Enclosure 1

**Kairos Power Response to NRC Questions 2.5-1, 2.5-2, 2.5-3, and 2.5-4
(Non-Proprietary)**

UPDATED FIGURE 2.5-2 Subsurface Profile A-A'

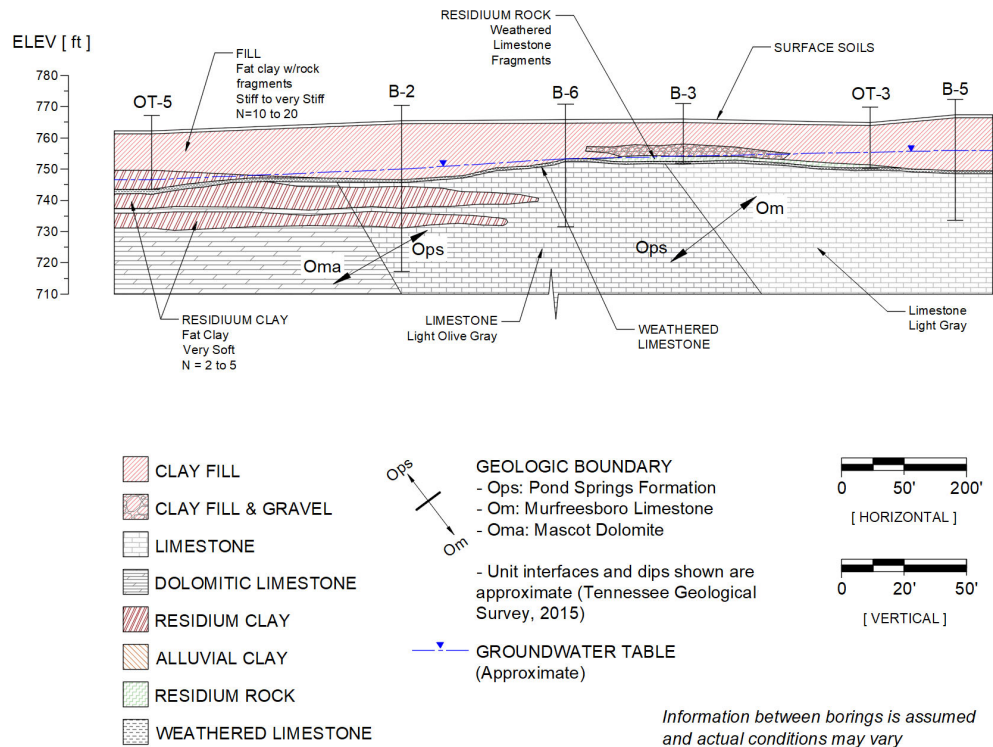
Geologic cross-section A-A' (Figure 2.5-2) appears to be missing the Mascot Dolomite, which is shown on the map (Figure 2.5-1) but not in the cross-section. Provide a new cross-section that includes all geologic units shown on the surface and encountered in the subsurface.

Figure 2.5-2 has been updated to add the Mascot Dolomite, consistent with Figure 2.5-1. Location of interfaces and dips are indicated as approximate.

The PSAR Section 2.5 Figure 2.5-2, Subsurface Profile A-A' has been deleted and replaced by the updated Figure 2.5-2 (attached). This change will be included in a future revision to the PSAR.
